JLRTB02149NAS2

TECHNICAL BULLETIN

Fuel Vapor Smell in Passenger Compartment - Further Enhancements

MODEL:	MODEL YEAR:	ASSEMBLY PLANT:	APPLICABILITY:
Range Rover (LK)	2022 Onwards	Solihull	INGENIUM I6 3.0L Petrol/V8 T/C 4.4L Petrol
Range Rover Sport (L1)	2023 Onwards	Solihull	INGENIUM I6 3.0L Petrol/V8 T/C 4.4L Petrol

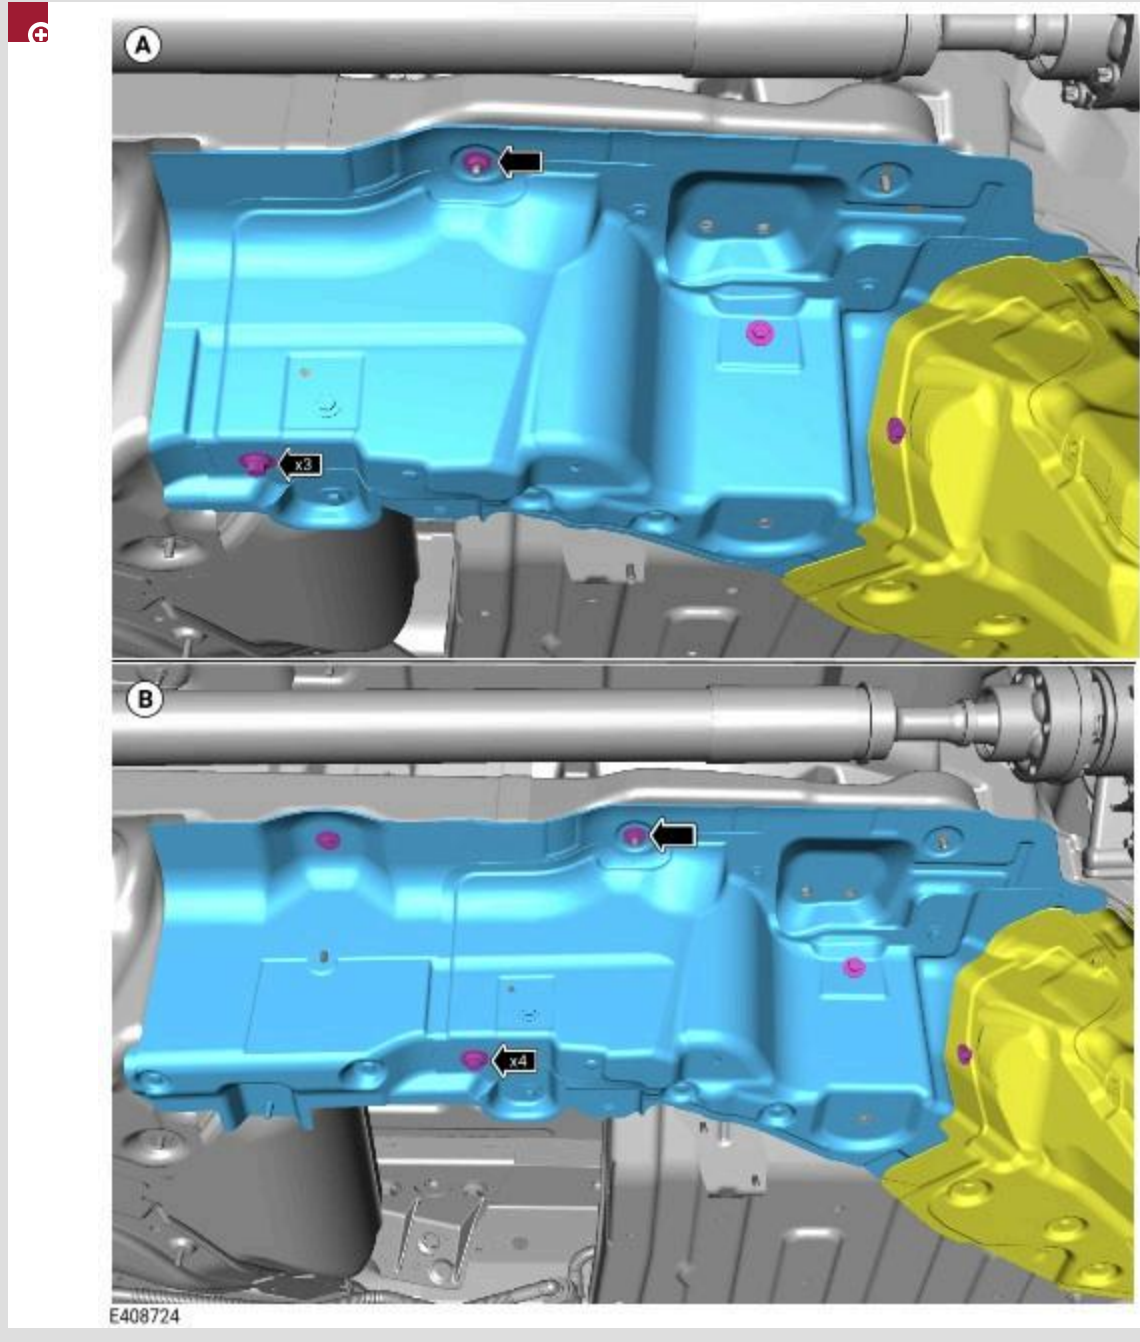
- **(A) SWB INGENIUM I6 3.0L Petrol vehicles from 2025 model year -** Install the new left heatshield.
 - Install the nut previously removed.
 - Torque: **5Nm**
 - Install the bolt previously removed.
 - Torque: **5Nm**

- **(B) LWB INGENIUM I6 3.0L Petrol vehicles from 2025 model year - Install the new left heatshield.**
 - Install the nut previously removed.
 - Torque: **5Nm**
 - Install the 3 bolts previously removed.
 - Torque: **5Nm**

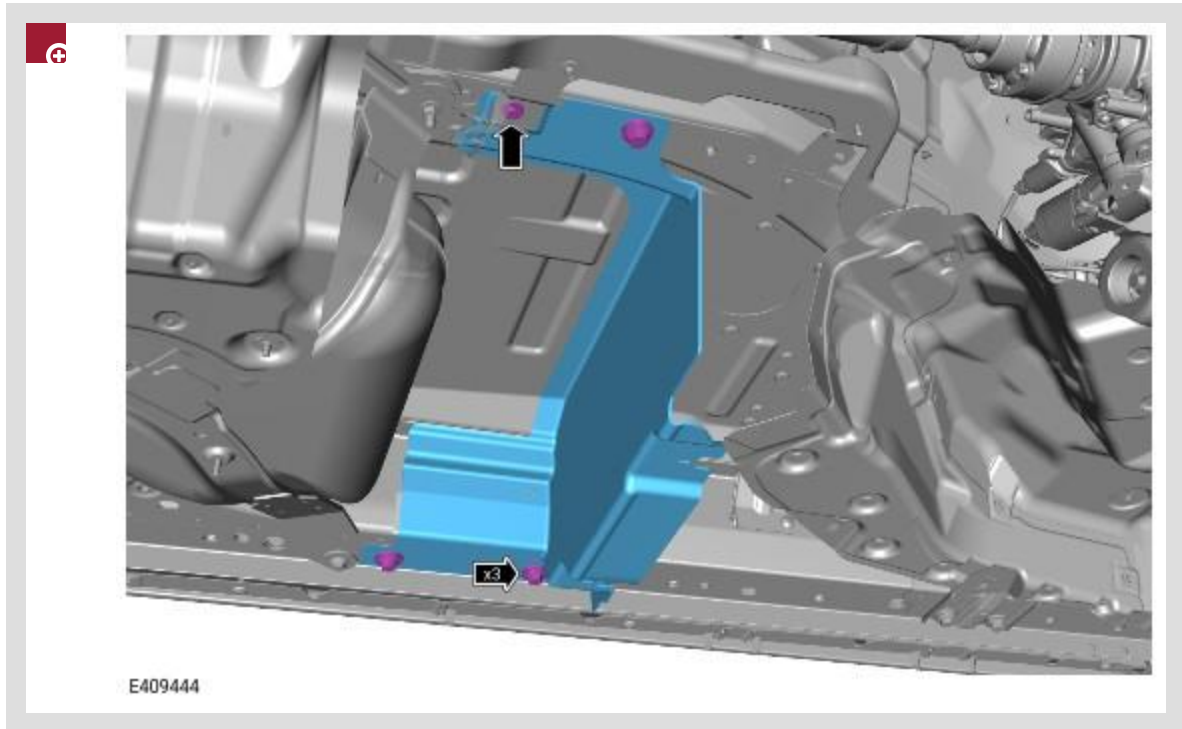
Install the left fuel tank heatshield deflector in the location shown in the illustration.

- Install the bolt previously removed.
 - Torque: **5Nm**

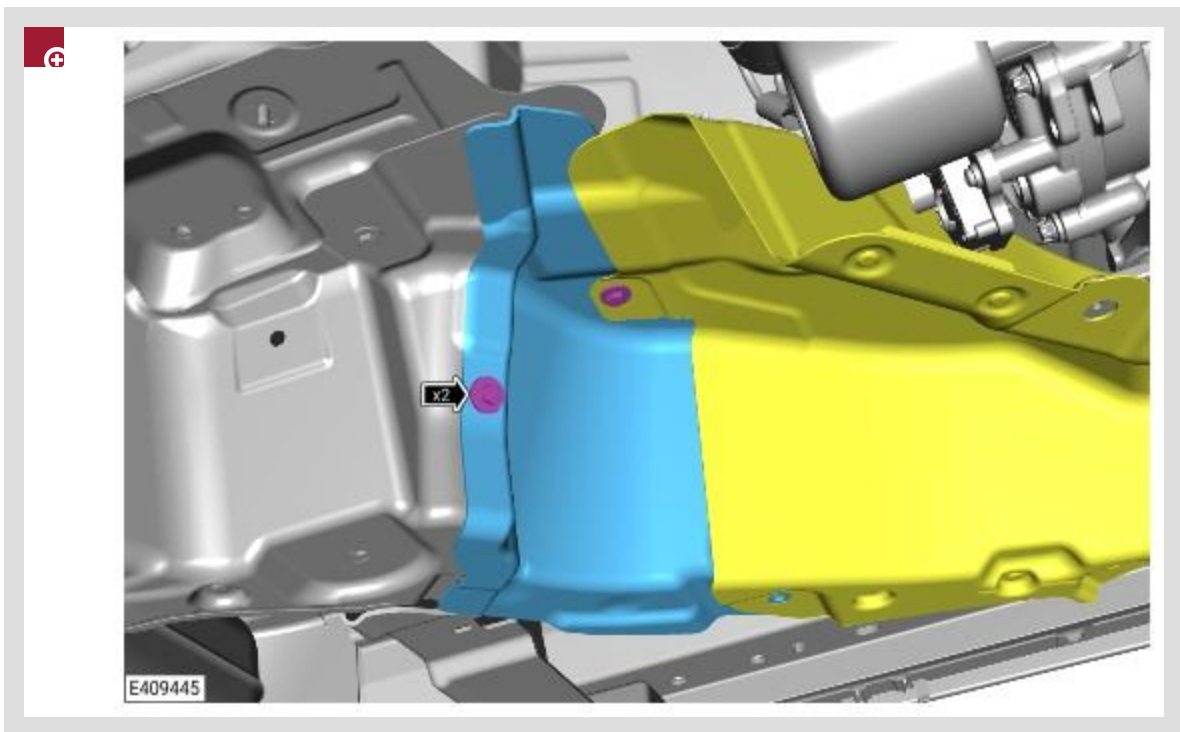
Refer to the applicable illustration for the installation of the new left center heatshield.

- **(A) SWB V8 T/C 4.4L Petrol NC10 vehicles** - Install the new left heatshield.
 - Install the nut previously removed.
 - Torque: **5Nm**

- Install the bolt previously removed.
 - Torque: **5Nm**
- **(B) LWB V8 T/C 4.4L Petrol NC10 vehicles** - Install the new left heatshield.
 - Install the nut previously removed.
 - Torque: **5Nm**
 - Install the 2 bolts previously removed.
 - Torque: **5Nm**

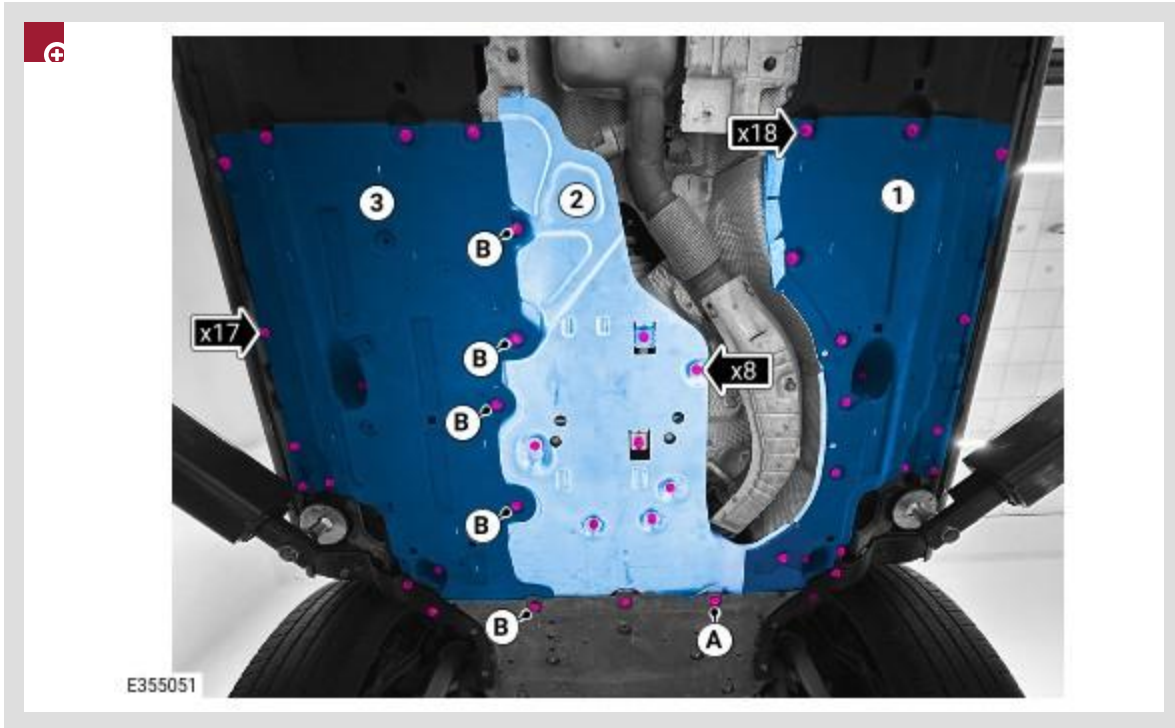
If a single piece transmission undershield was discarded, a new 3 piece transmission undershield must be installed.

Install the new 3 piece transmission undershield.

1. Install the right transmission undershield section.

- Install the 17 bolts.
 - Torque: **5.4Nm**

2. Install the left transmission undershield section.

- Install the 18 bolts.
 - Torque: **5.4Nm**

3. Install the center transmission undershield section.

- Install the 13 bolts.
 - Torque: **5.4Nm**

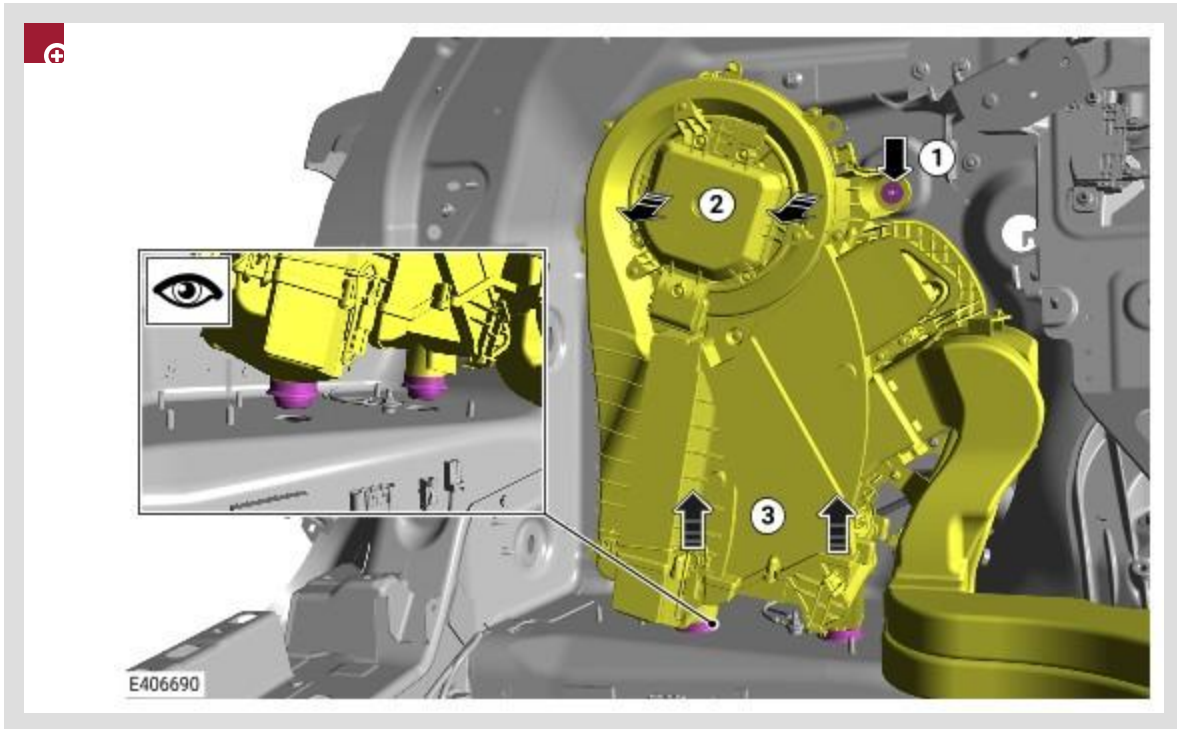
Only remove the drain grommet shown in the illustration. The grommet further forward on the auxiliary climate control assembly is for location purposes only.

Renew the drain grommet shown in the illustration.

- Remove and discard the drain grommet.
- Install the new reduced inner diameter drain grommet, shown with the **GREEN** ✓ in the illustration.

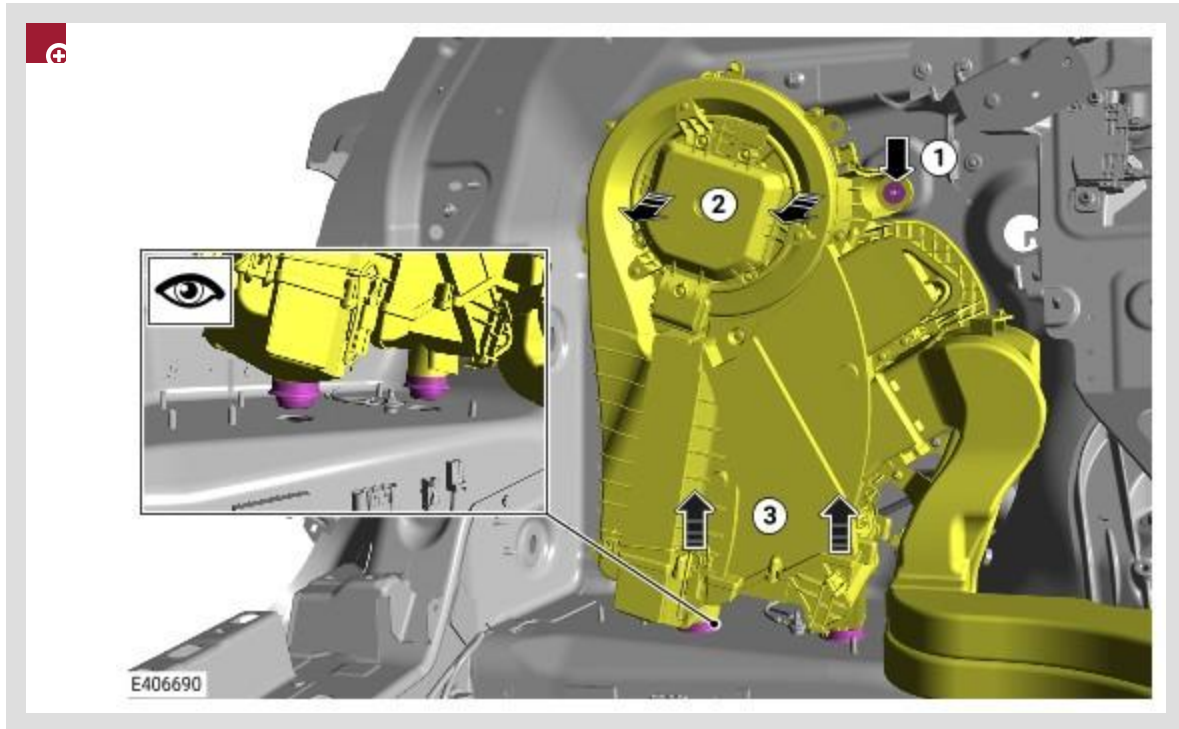
Only remove the drain grommet shown in the illustration. The grommet further forward on the auxiliary climate control assembly is for location purposes only.

Renew the drain grommet shown in the illustration.

- Remove and discard the drain grommet.
- Install the new reduced inner diameter drain grommet, shown with the **GREEN ✓** in the illustration.

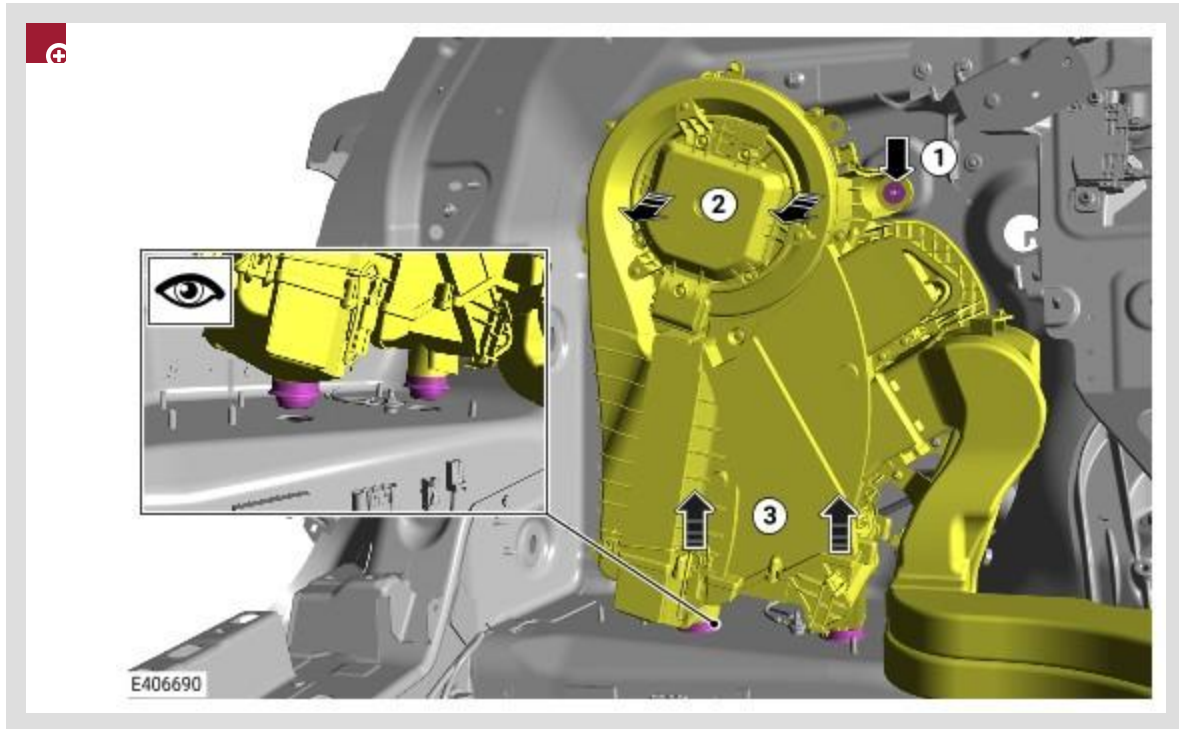
Only remove the drain grommet shown in the illustration. The grommet further forward on the auxiliary climate control assembly is for location purposes only.

Renew the drain grommet shown in the illustration.

- Remove and discard the drain grommet.
- Install the new reduced inner diameter drain grommet, shown with the **GREEN** ✓ in the illustration.
